Attachment 1
NRC3-12-0003

Table of RAI Response Dates
(5 pages)

Response to RAI Letter No. 70
(eRAI Tracking No. 6217)

RAI Question No. 02.05.02-17

Figure 3.7.1-242: Response Spectrum for Spectrally Matched Horizontal (H1) Component for the Fermi 3 RB/FB SSI FIRS.

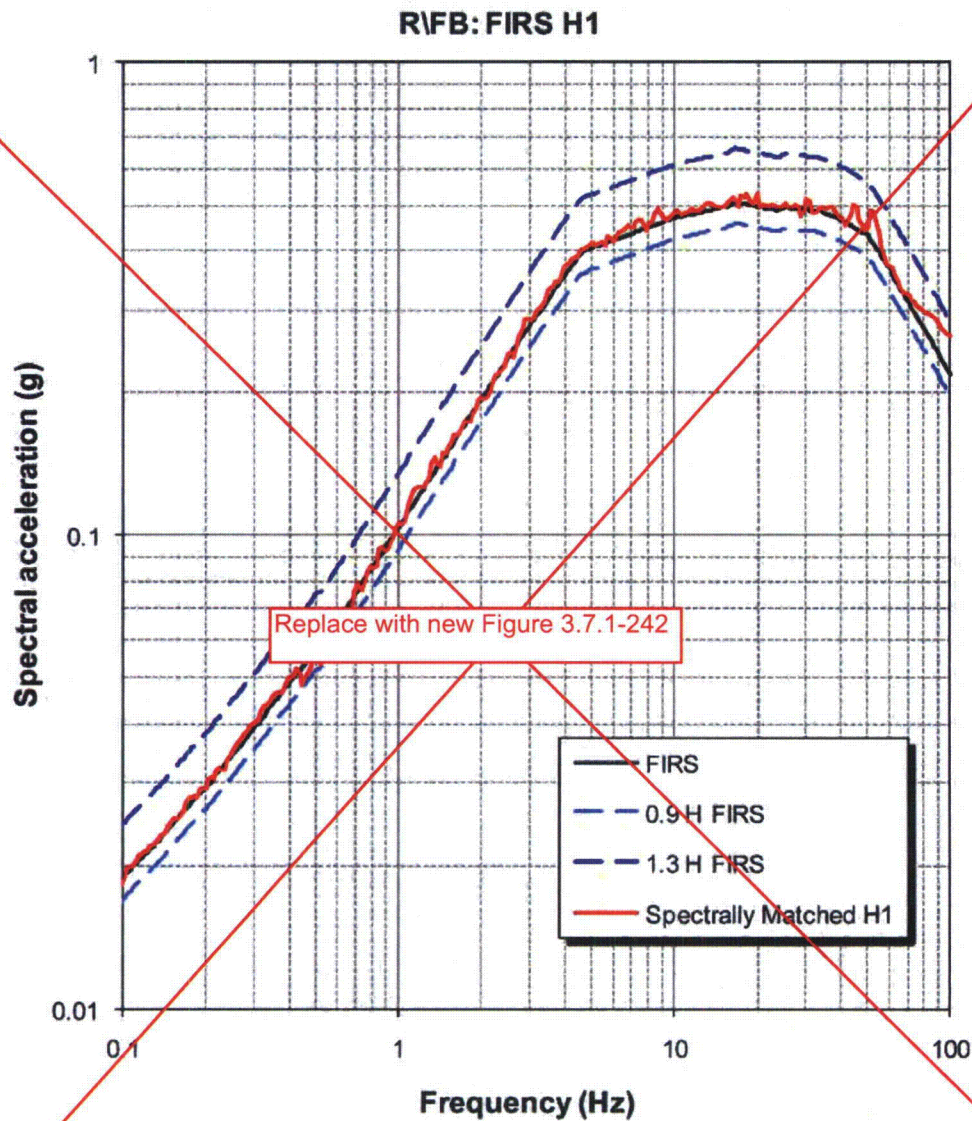
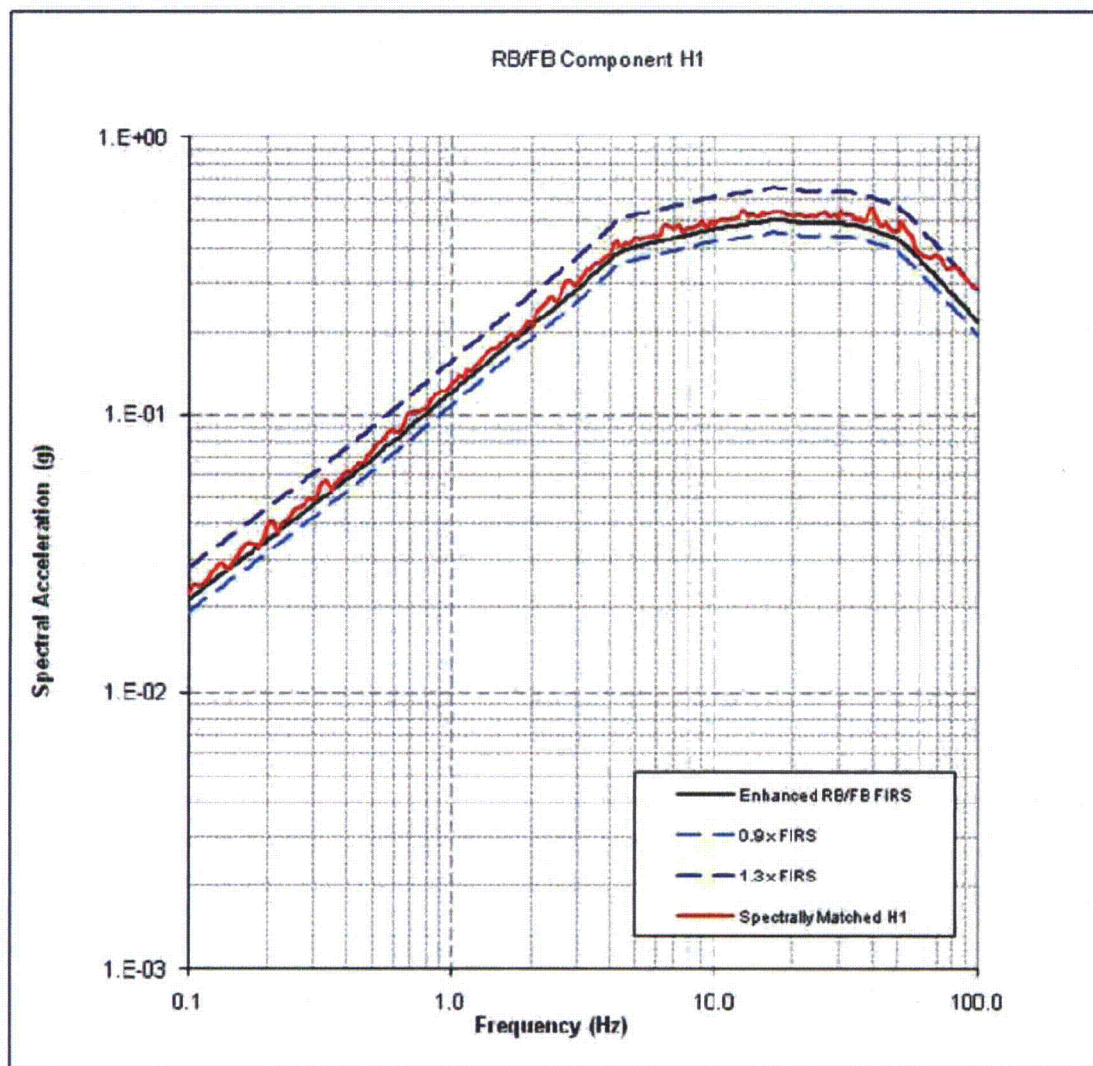
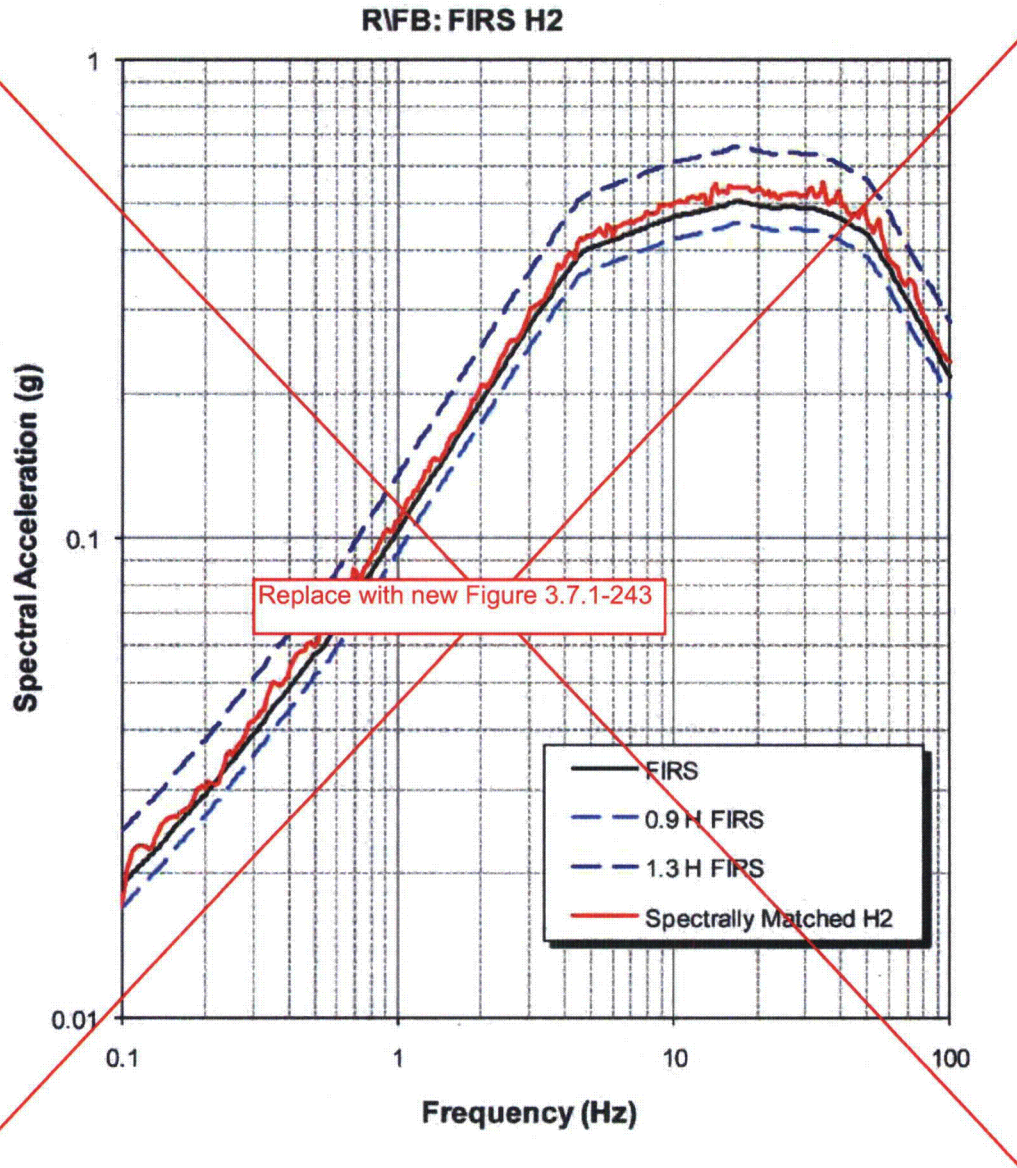
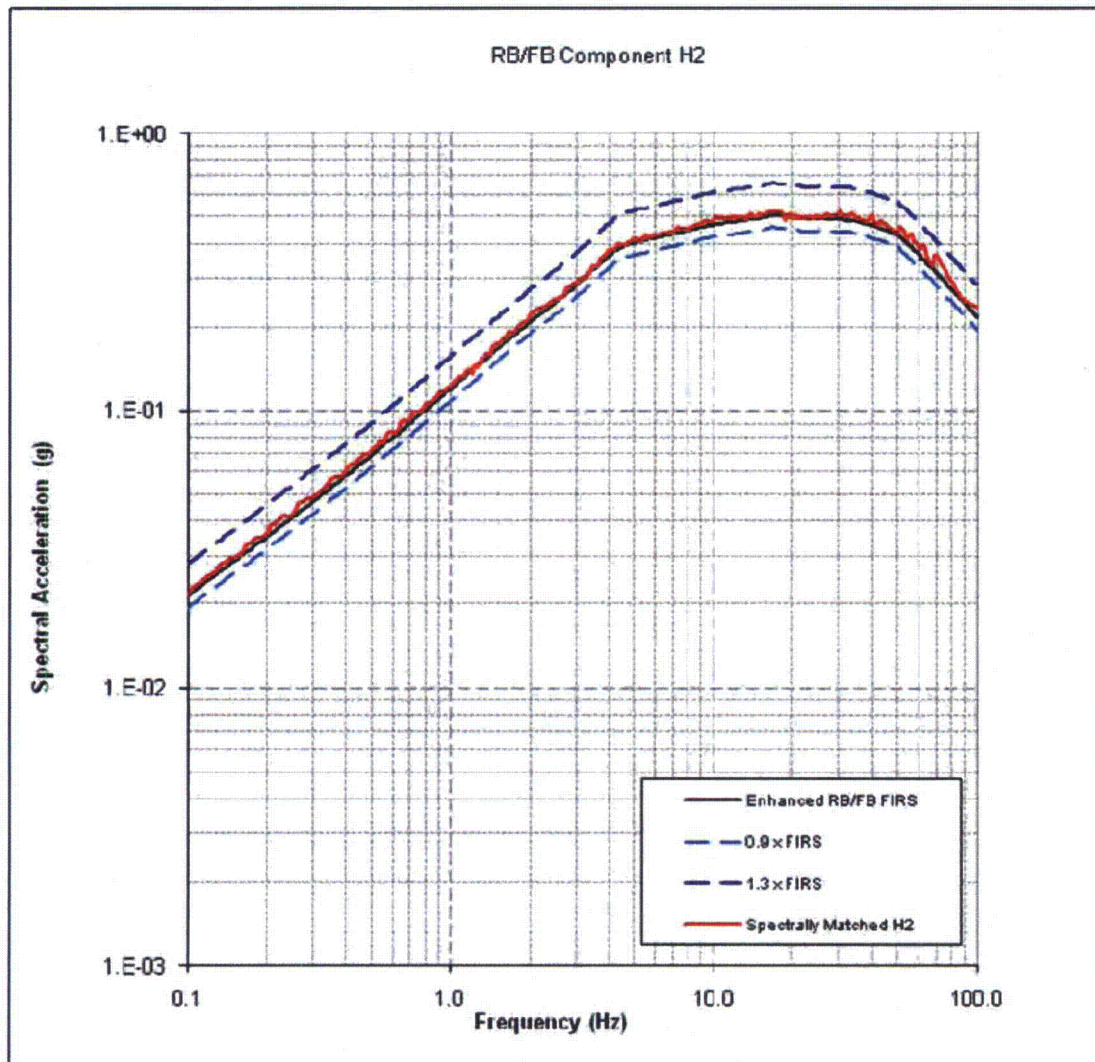
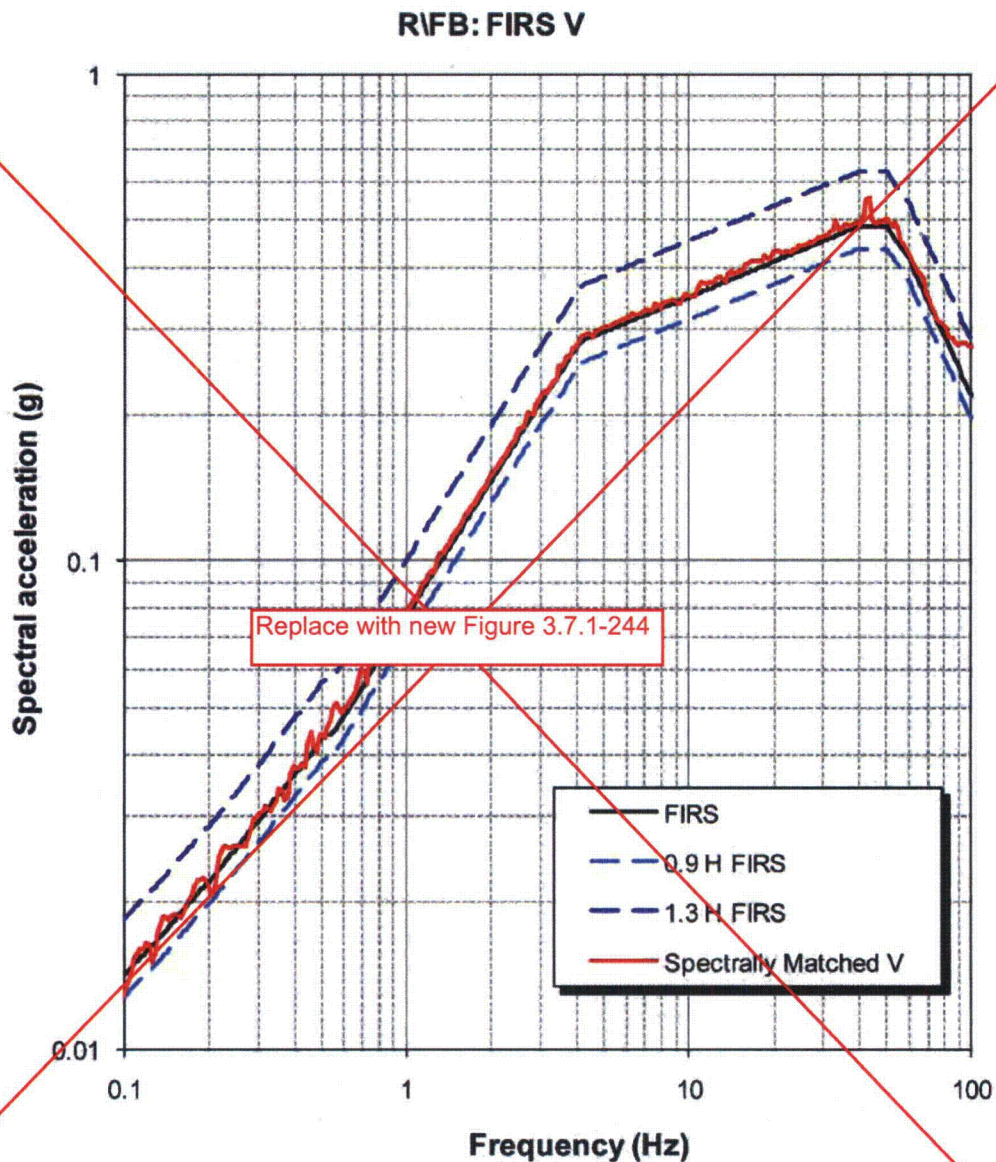
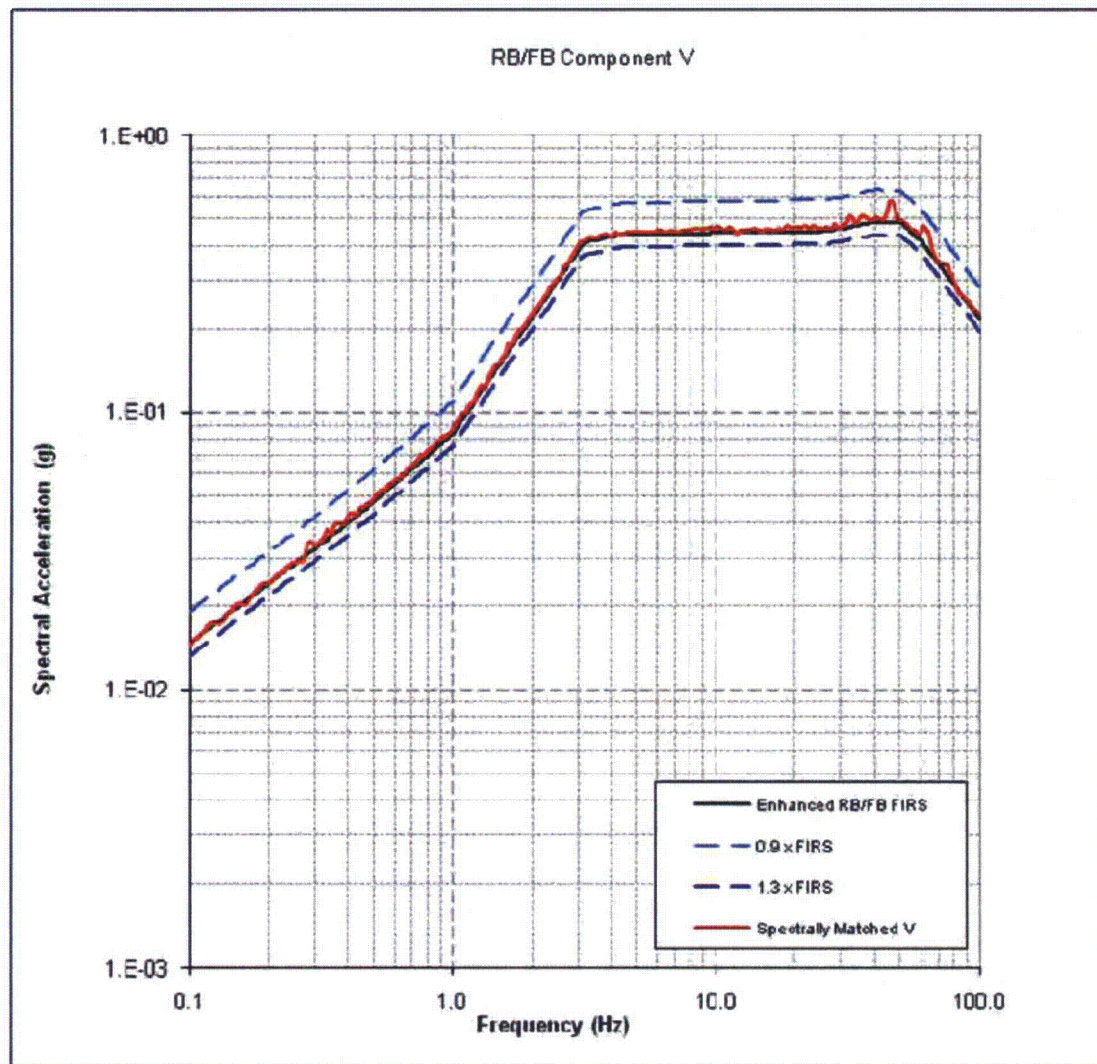
03.07.01-7	1	As such, the applicant is requested to provide further justification of the acceptability of the PGV/PGA values for the artificial time histories being higher than the selected controlling earthquake.	February 16, 2012

03.07.01-7	2	The applicant is also requested to provide comparison of the response spectra of the artificial time histories and the estimated target spectra (SSI FIRS) at 2% and 10% damping values for RB/FB and CB.	February 16, 2012

Figure 3.7.1-204 through Figure 3.7.1-206 show the comparison of the response spectrum in the two horizontal and one vertical direction for the following:

- The SSI FIRS.
- 1.3 times (30 percent greater) the SSI FIRS.
- 0.9 times (10 percent less) the SSI FIRS at the RB/FB and CB levels.
- Response spectrum for the spectrally matched time history

The response spectra for the spectrally-matched time histories were calculated for comparison with the SSI FIRS at 301 spectral frequency points (or 100 frequencies per spectral decade). As shown in Figure 3.7.1-204 through Figure 3.7.1-206, the 5 percent damped response spectra of the spectrally-matched time histories are within the range of 0.9 to 1.3 times the SSI FIRS at any frequency. Therefore, the criteria of Option 1, Approach 2 of SRP 3.7.1 Section II (Acceptance Criteria), Revision 3, are satisfied.
